ADDENDUM NUMBER 1

- 1.01 DATE: October 12,2023**
- 1.02 PROJECT: ELMORE GYM ELECTRICAL SERVICE REPLACEMENT**
- 1.03 PROJECT NUMBER: 26239.0, DCM/BC NO. 2023098, PSCA NO. 2082**
- 1.04 OWNER: ALABAMA A&M UNIVERSITY**
- 1.05 ARCHITECT: HYDE ENGINEERING, INC.**

GROUND FLOOR PLAN
ELECTRICAL
 SCALE 1/16"=1'0"

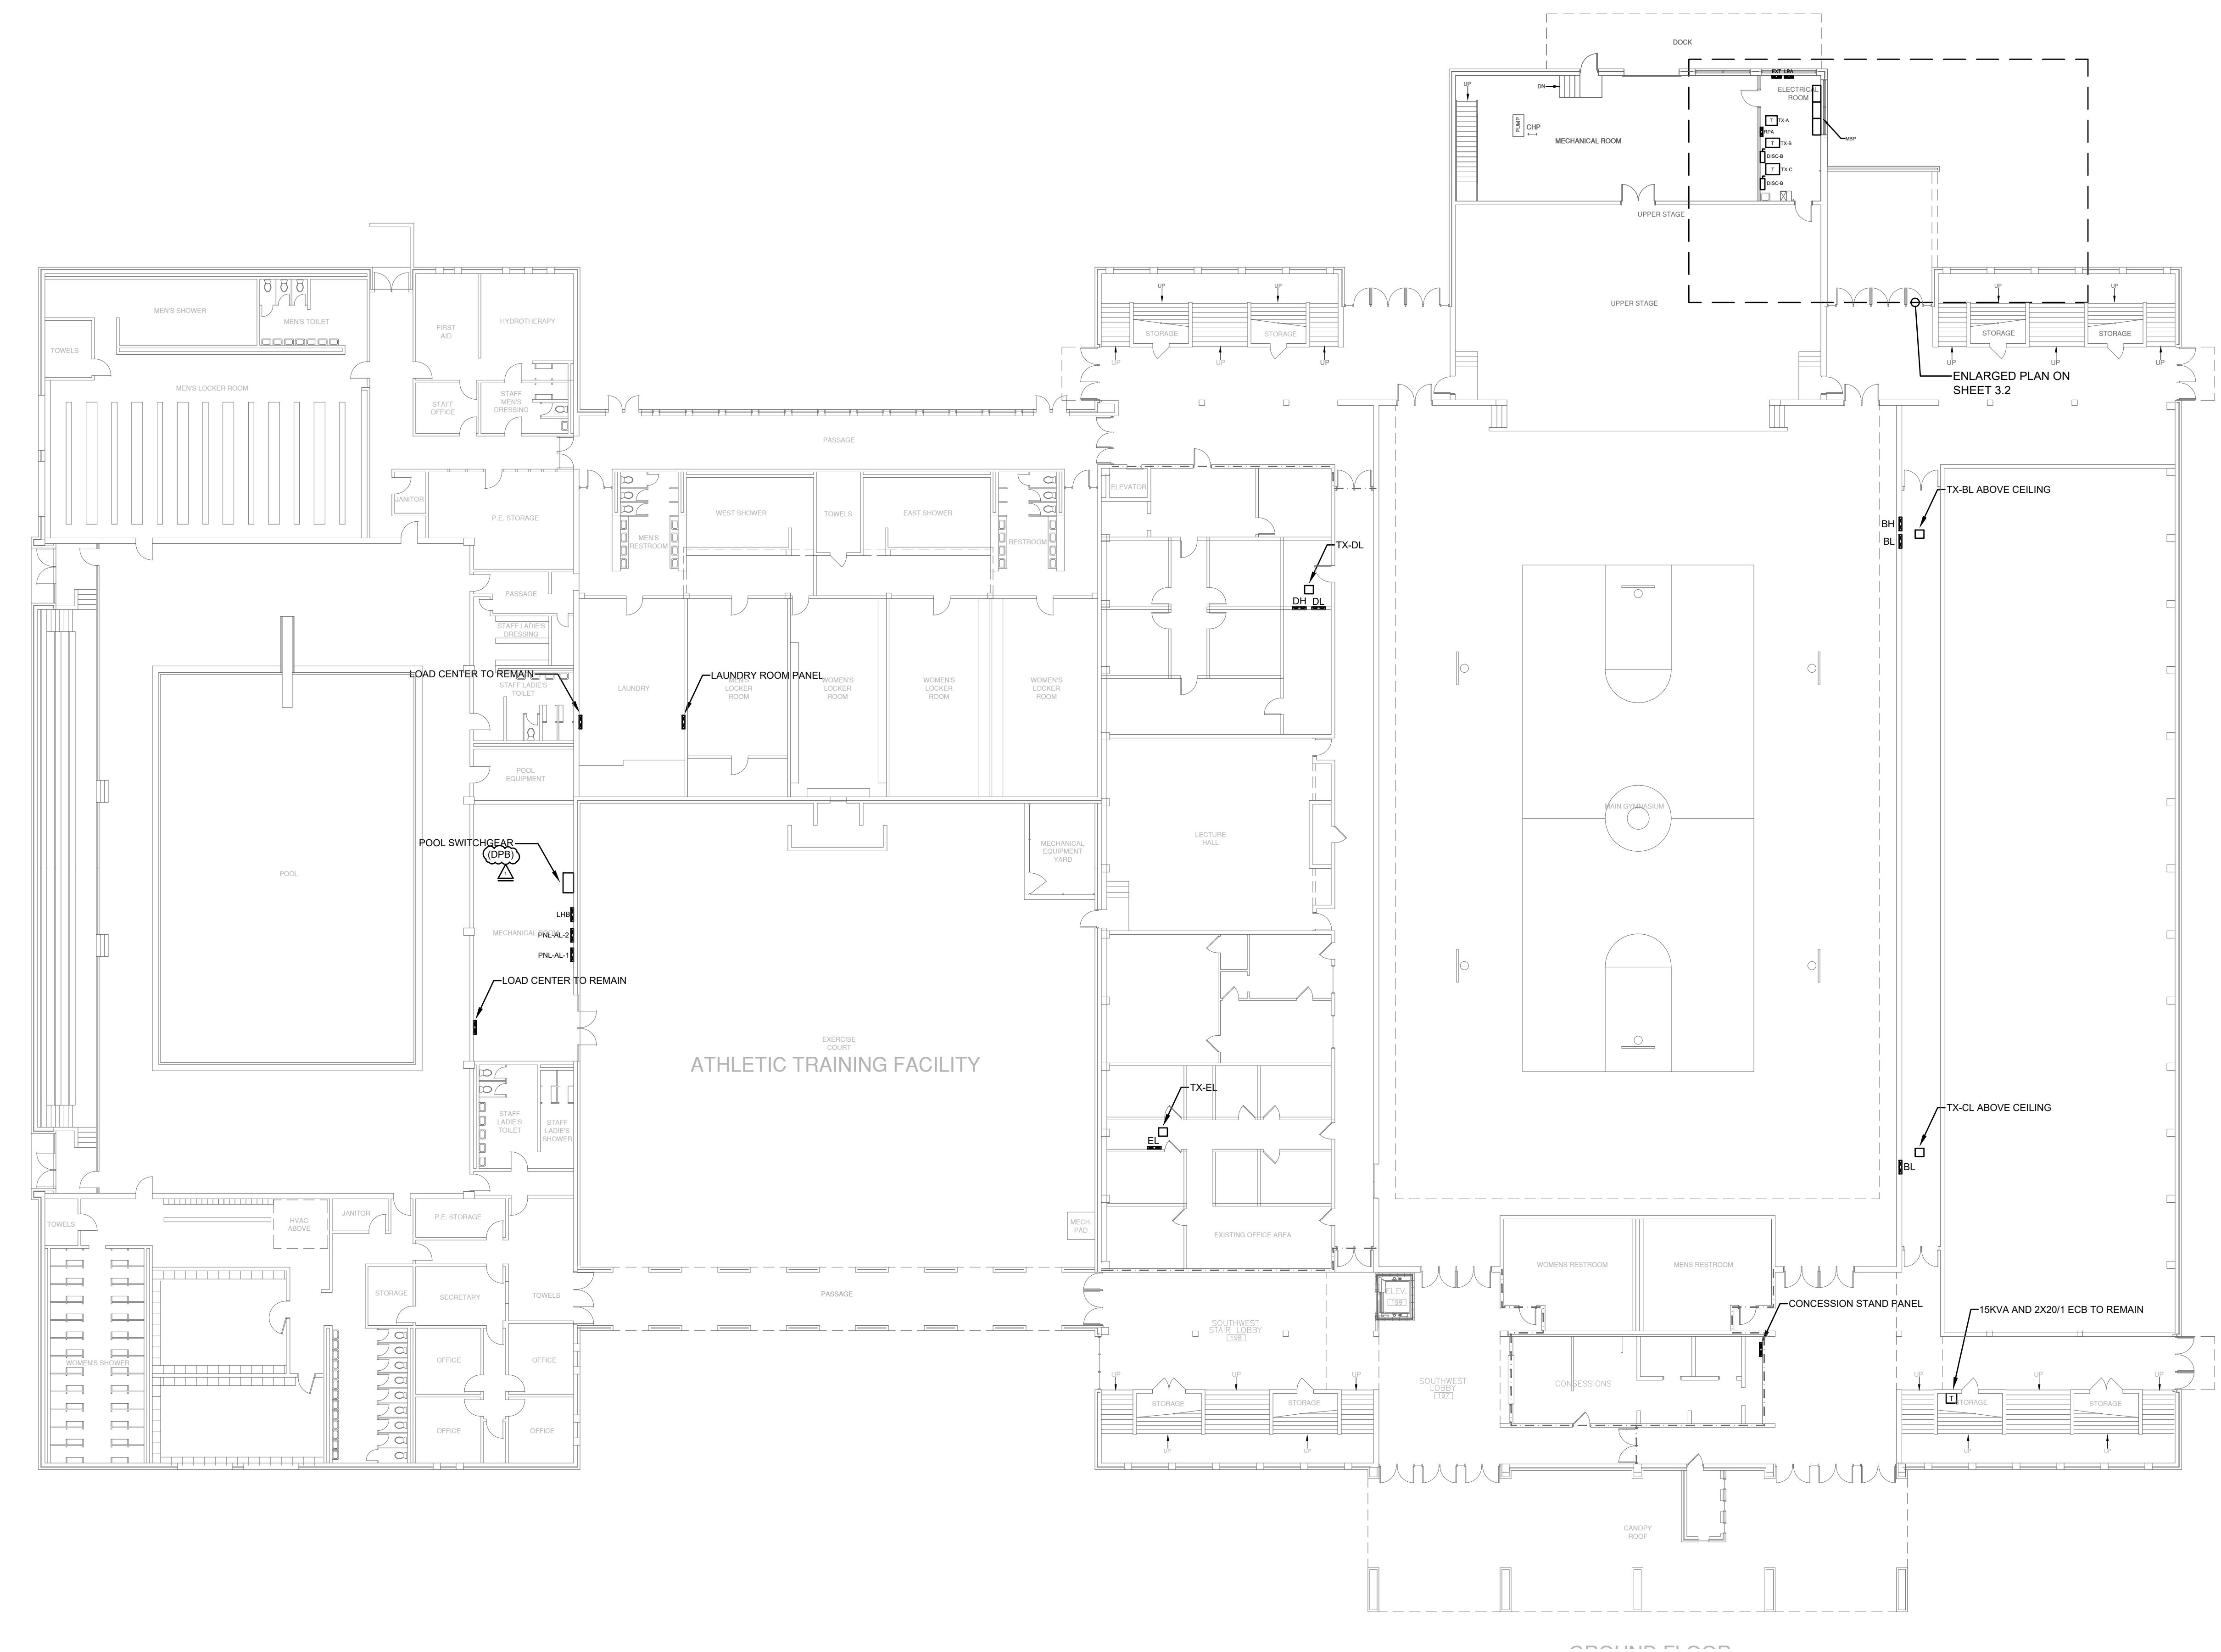
A. Ground Floor Plan, pool switchgear leader updated.

DRAWING NO.
E3.2

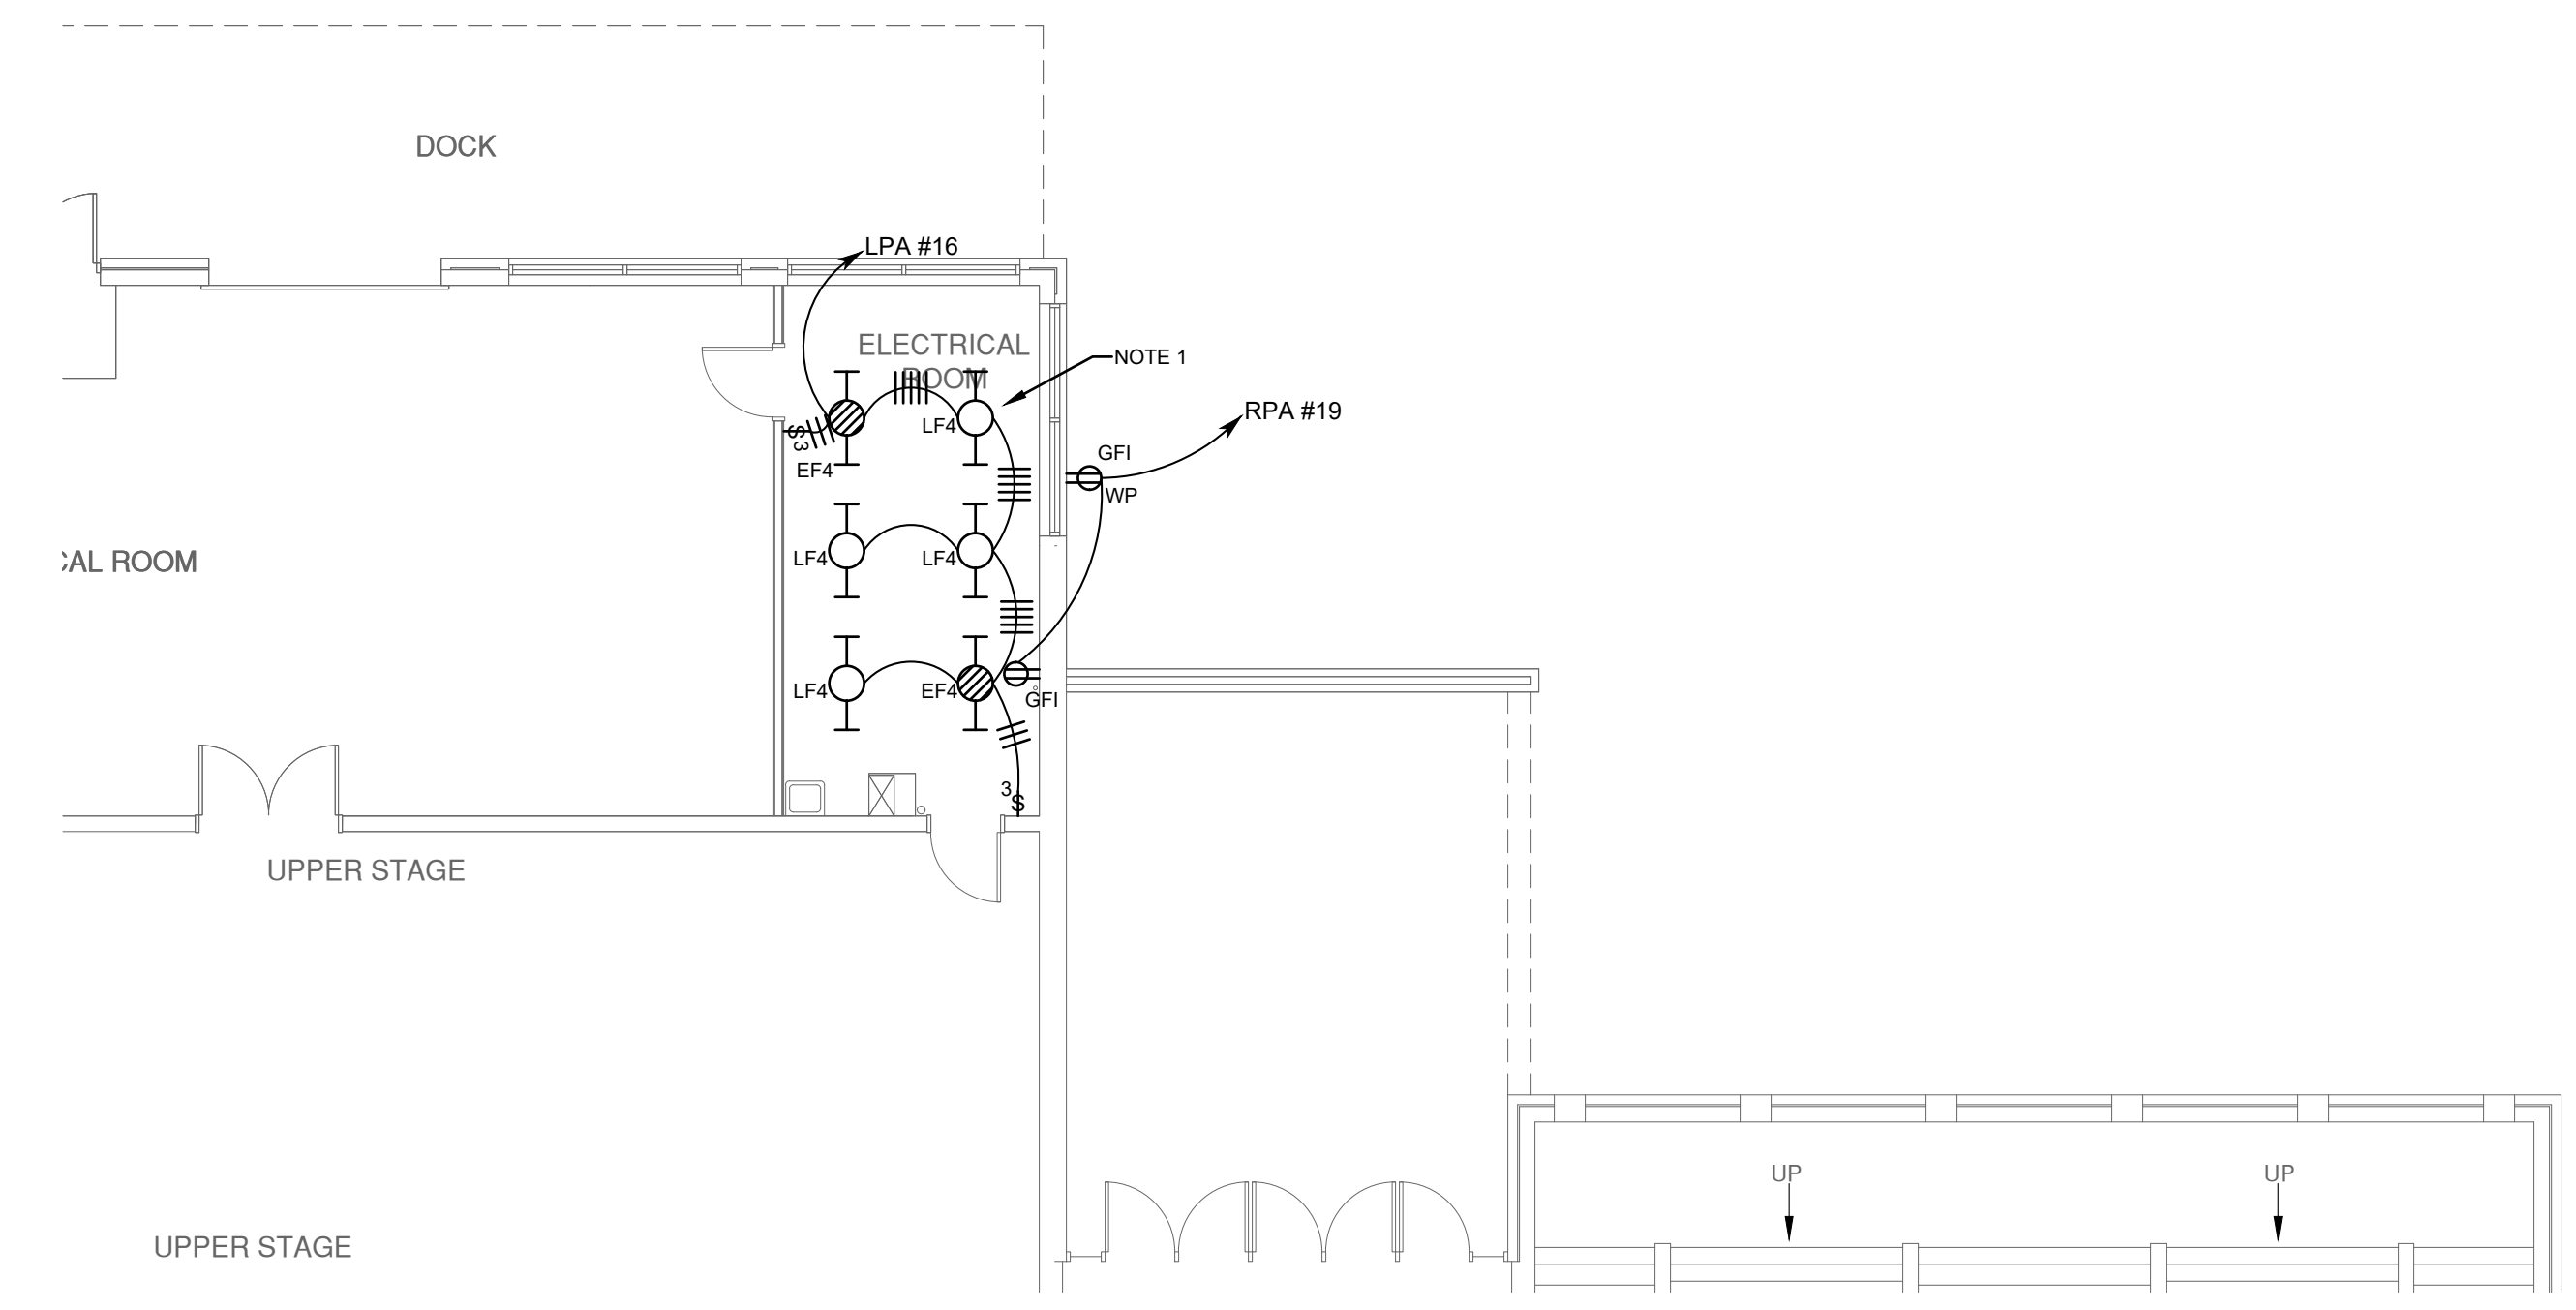
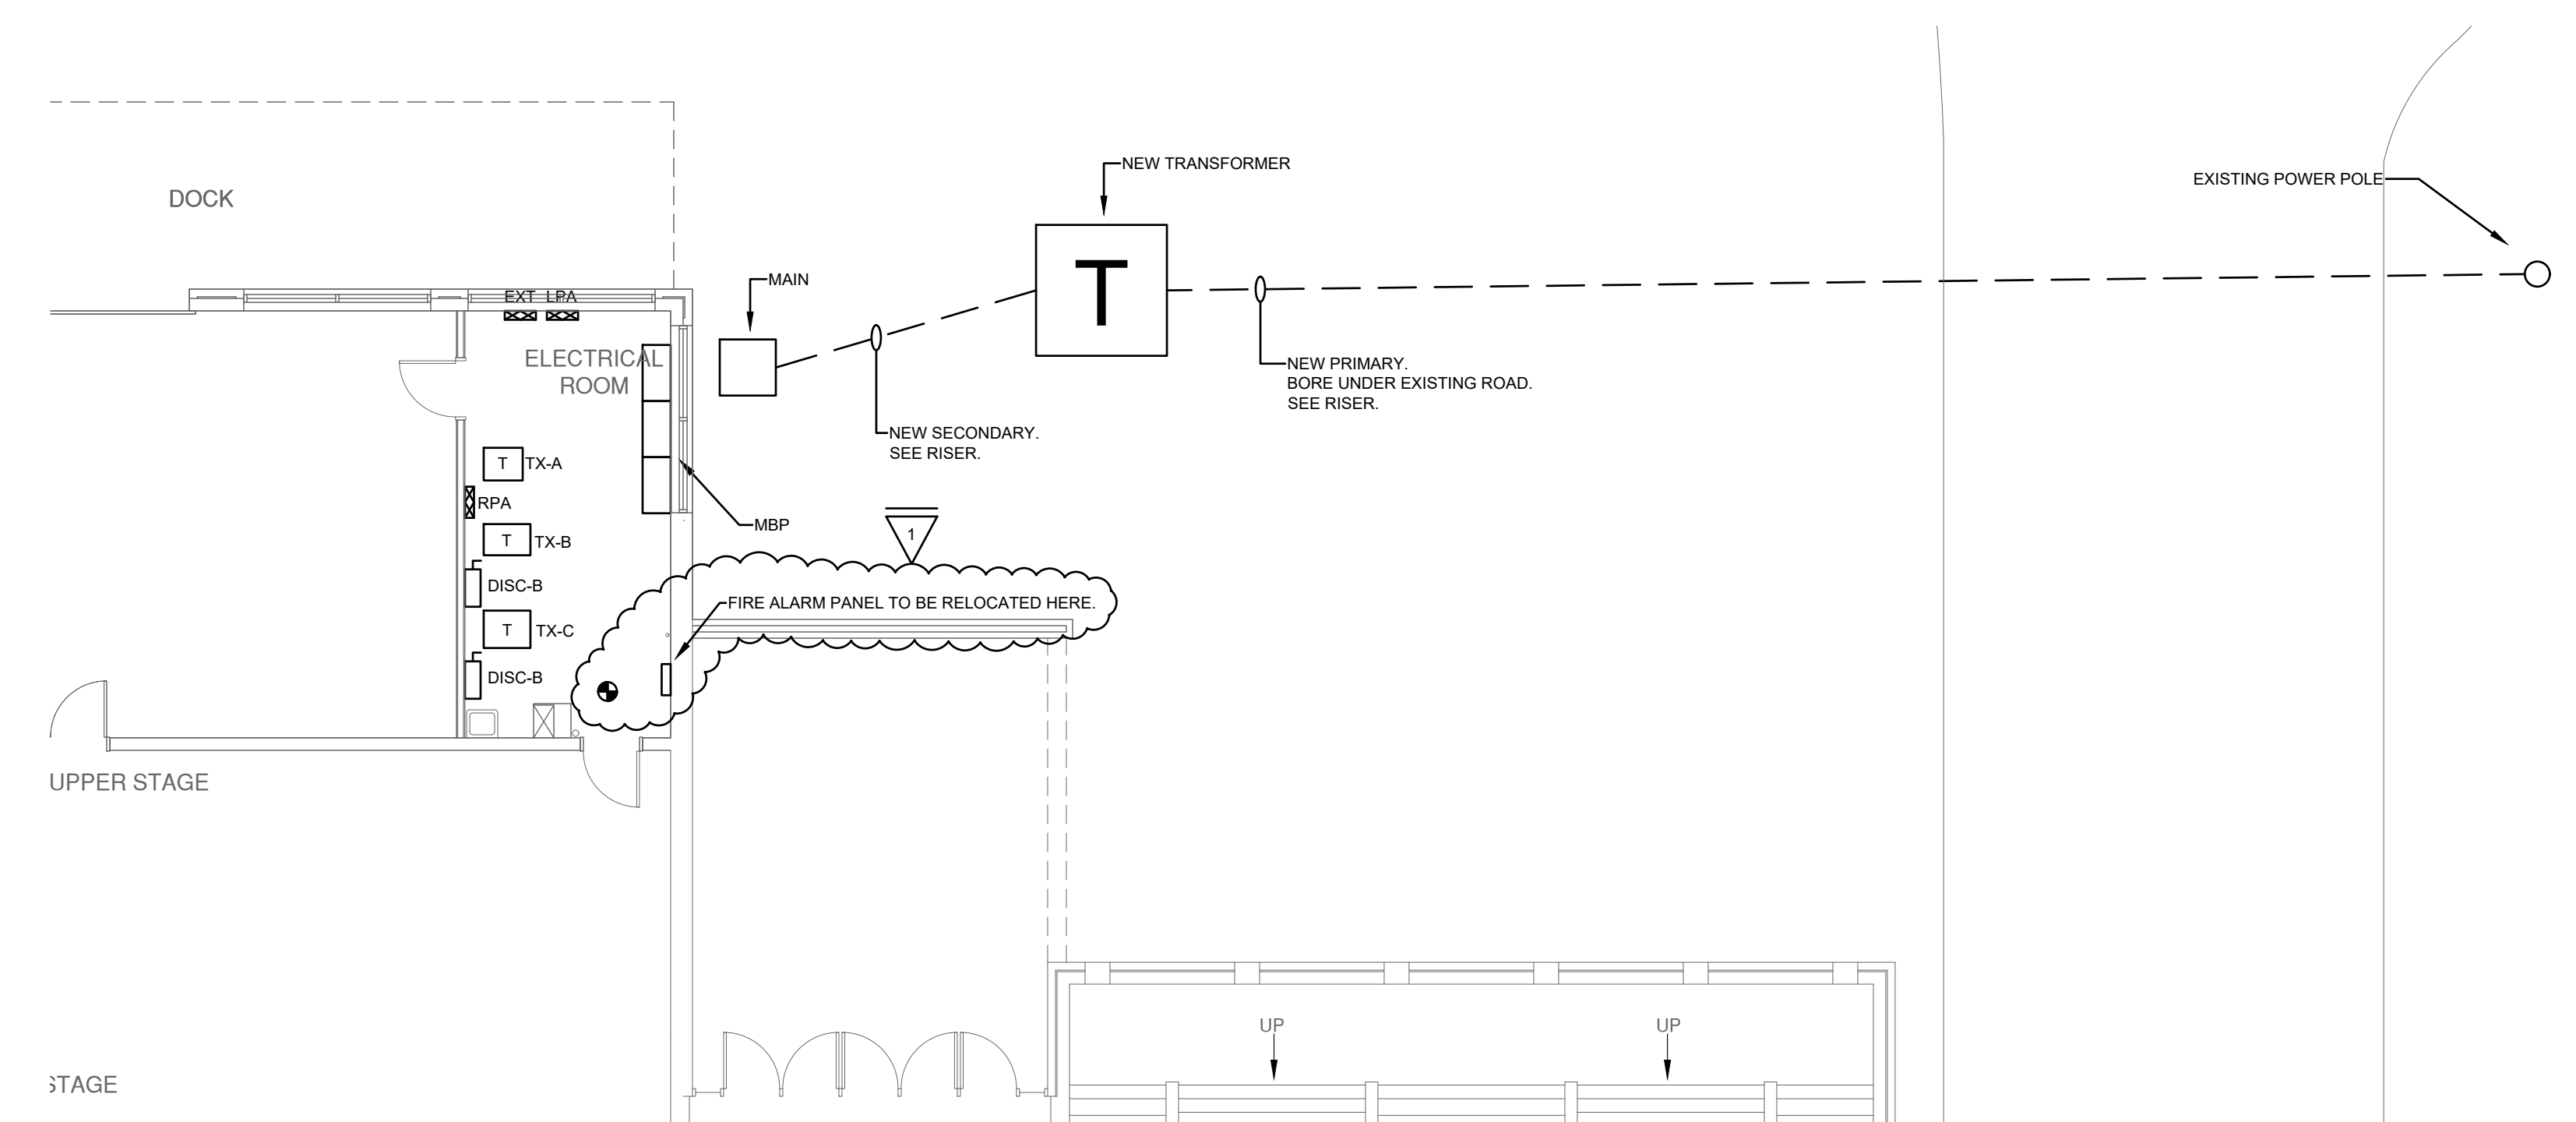
4.06 SHEET E3.2 – SECOND FLOOR PLAN AND ENLARGED PLANS

A. Upper Enlarged Plan, Note #2 added.

B. Lower Enlarged Plan, Note #1 added. Fire alarm circuit shall be routed to panel RPA. Breaker shall have a red lock on device and be labeled as fire alarm control panel.

- NOTES:
- CONTRACTOR SHALL RECERTIFY SYSTEM ONCE PANEL IS RELOCATED. NOTIFY OWNER OF ANY TROUBLES PRIOR TO RELOCATING PANEL. FIRE ALARM CONTRACTOR SHALL BE LICENSED BY STATE FIRE MARSHALL'S OFFICE.
